## 2024.03.20 TSW210 DIN Rail bracket change

PCN Number: PCN\_TSW2010\_2023.03.20

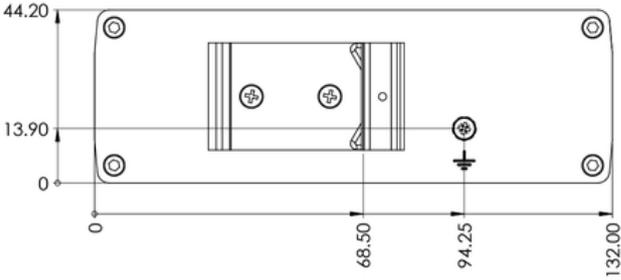
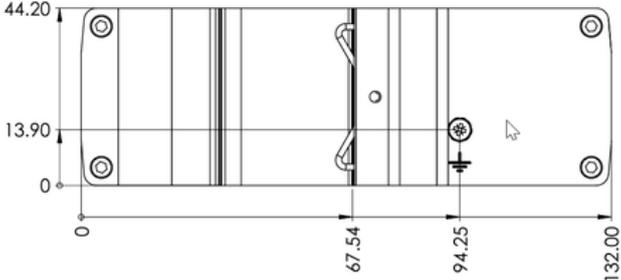
Change type	Mechanical	
Detailed description	<p>Beginning in Q2 of 2024, the current screw-on DIN Rail bracket in the TSW210 switch will be replaced with an integrated one. The new DIN Rail bracket will be shifted to the left by 0.96 mm.</p> <p>Please note that this change will be implemented gradually, throughout a 3-month transitional period starting from Q2 2024, batch 33. During this period, your shipments of TSW210 may consist of either the current screw-on DIN Rail bracket or the new one described above. For inquiries regarding custom order codes, please contact your designated sales representative.</p>	
	<p>Old DIN Rail bracket:</p> 	<p>New DIN Rail bracket:</p> 
	<p>Dimensions of old DIN Rail bracket:</p> 	<p>Dimensions of new DIN Rail bracket:</p> 
	Packaging dimensions will not change.	
Change reasons	Structural improvement
